JASIC reply to OICA comments

TF TA

14th November, 2022

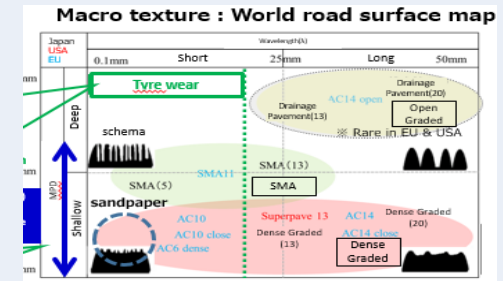
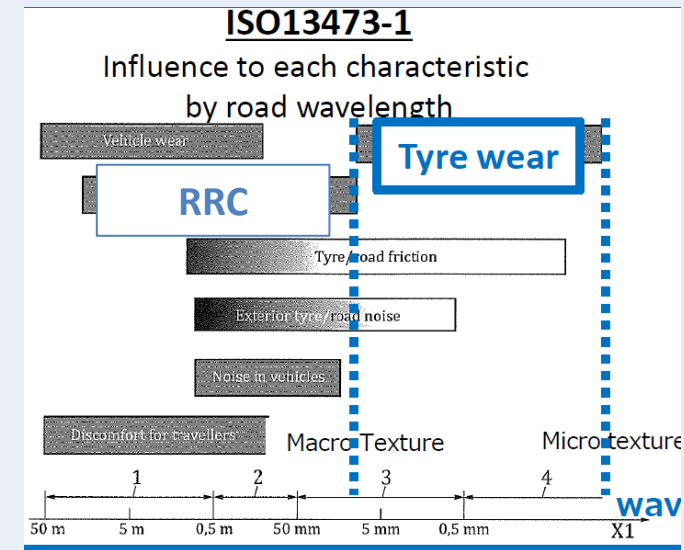
Unclear if drum surface characterization is representative of real life road surface / pavement*

The chart shown below is the result of our investigation on asphalt surface specifications of the world. It expresses characteristics of asphalt surface by MPD. (It is mentioned in Q&A list(TA-05-02) line 85)

From ISO13473-1, the wavelength of the affected road surface is different for RRC and Tyre wear, and a suitable road surface shape is adopted for Tyre wear.
